## U-LINE 2006 INSERT PANEL CHANGES

**TO MOVE A 2075 OR 2015 DOOR PANEL TO A 2175 OR 2115 DOOR:**

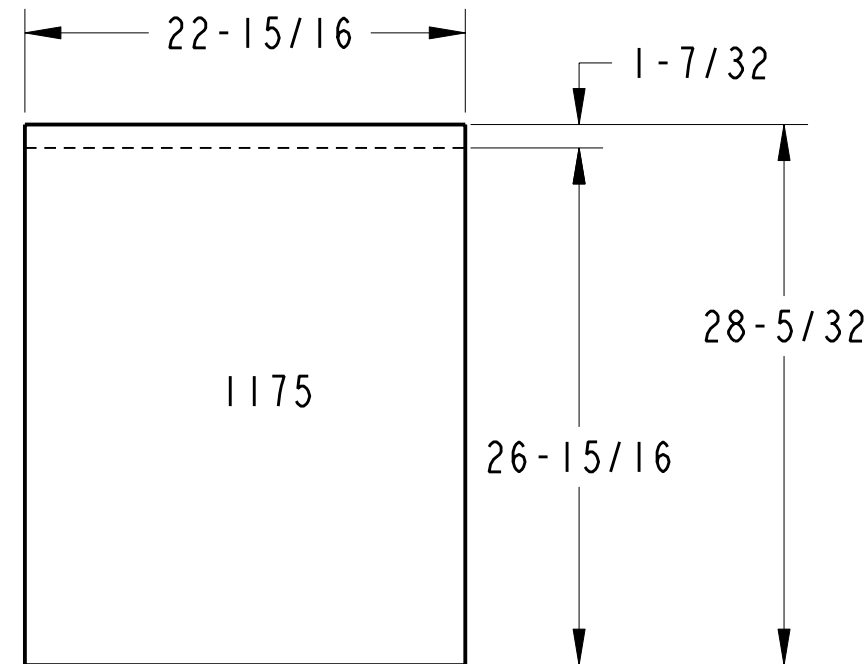
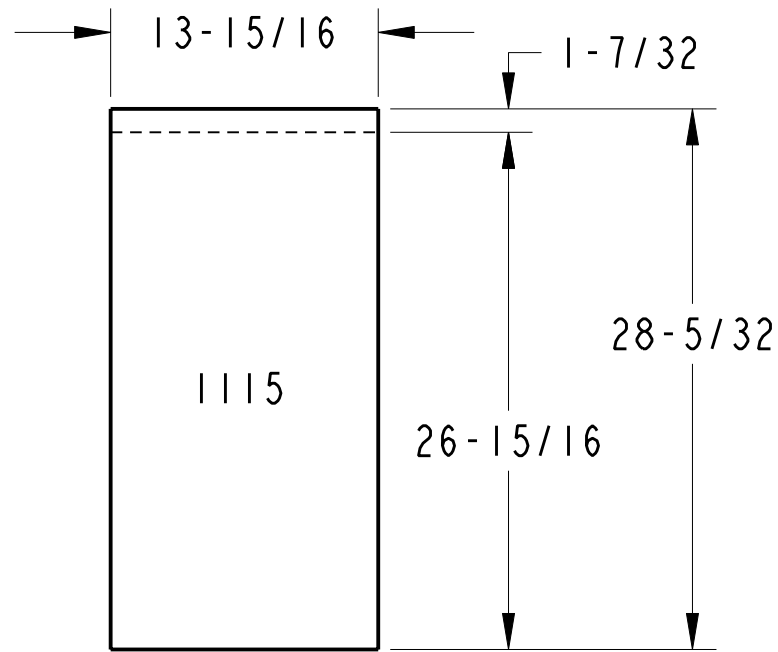
1. THE HEIGHT IS SHORTENED  $\frac{15}{32}$ .
2. THE HEIGHT OF THE PANEL MUST BE CHANGED TO  $27\frac{11}{16}$ .
3. THE REVEAL OF  $\frac{1}{4}$  ON ALL FOUR SIDES FOR THIS PANEL DOES NOT CHANGE.
4. FOR RAISED PANELS ATTACHED TO INSERT PANELS THE RAISED PANEL MAY NOT BE TALLER THAN  $27\frac{3}{16}$ .
5. DEPENDING ON YOUR STYLE OF DOOR THE AMOUNT REMOVED MAY BE TAKEN FROM THE TOP AND/OR BOTTOM OF THE PANEL TO CENTER A DESIGN OR RAISED PANEL.

**TO MOVE A 2075 DRAWER PANEL TO A 2175 DRAWER:**

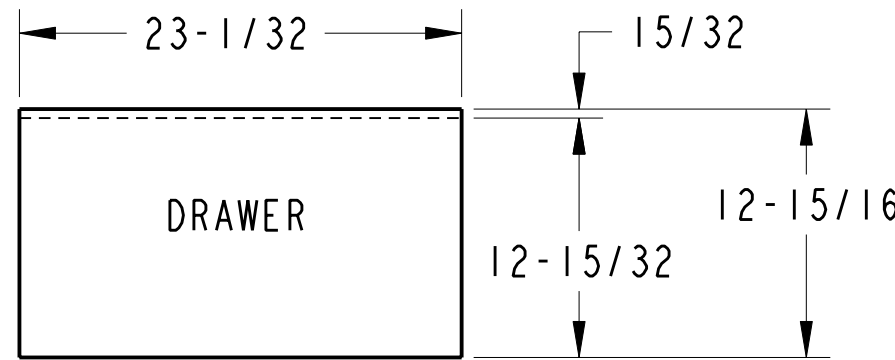
1. THE HEIGHT IS SHORTENED  $\frac{15}{32}$ .
2. THE HEIGHT OF THE PANEL MUST BE CHANGED TO  $12\frac{15}{32}$ .
3. THE REVEAL OF  $\frac{1}{4}$  ON ALL FOUR SIDES FOR THIS PANEL DOES NOT CHANGE.
4. FOR RAISED PANELS ATTACHED TO INSERT PANELS THE RAISED PANEL MAY NOT BE TALLER THAN  $11\frac{31}{32}$ .
5. DEPENDING ON YOUR STYLE OF DOOR THE AMOUNT REMOVED MAY BE TAKEN FROM THE TOP AND/OR BOTTOM OF THE PANEL TO CENTER A DESIGN OR RAISED PANEL.

**TO MOVE A 75 OR 15 DOOR PANEL TO A 1175 OR 1115 DOOR:**

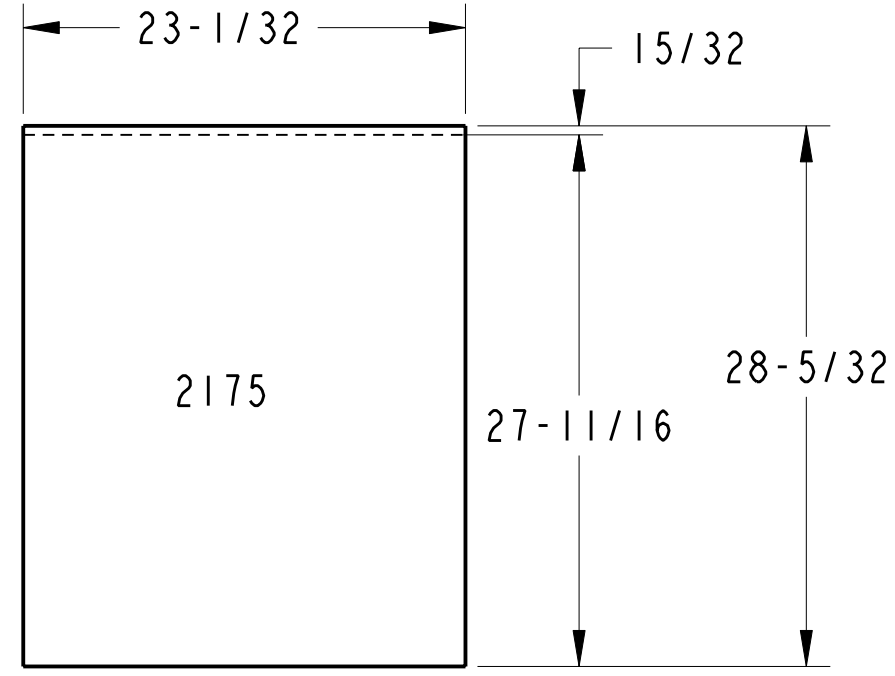
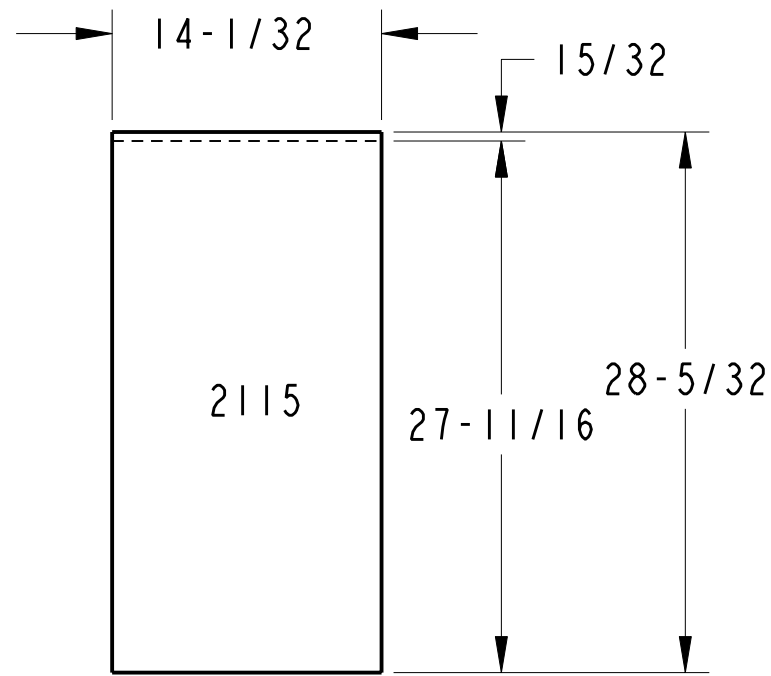
1. THE HEIGHT IS SHORTENED  $1\frac{7}{32}$ .
2. THE HEIGHT OF THE PANEL MUST BE CHANGED TO  $26\frac{15}{16}$ .
3. THE REVEAL FOR THIS PANEL HAS CHANGED, THE REVEAL IS  $\frac{1}{4}$  ON ALL FOUR SIDES. FOR 75 & 15 THE REVEAL ALONG THE TOP WAS  $\frac{1}{2}$ .
4. FOR RAISED PANELS ATTACHED TO INSERT PANELS THE RAISED PANEL MAY NOT BE TALLER THAN  $26\frac{7}{16}$ .
5. DEPENDING ON YOUR STYLE OF DOOR THE AMOUNT REMOVED MAY BE TAKEN FROM THE TOP AND/OR BOTTOM OF THE PANEL TO CENTER A DESIGN OR RAISED PANEL. MORE MAY NEED TO BE TAKEN FROM THE TOP THAN THE BOTTOM BECAUSE THE REVEAL CHANGED.
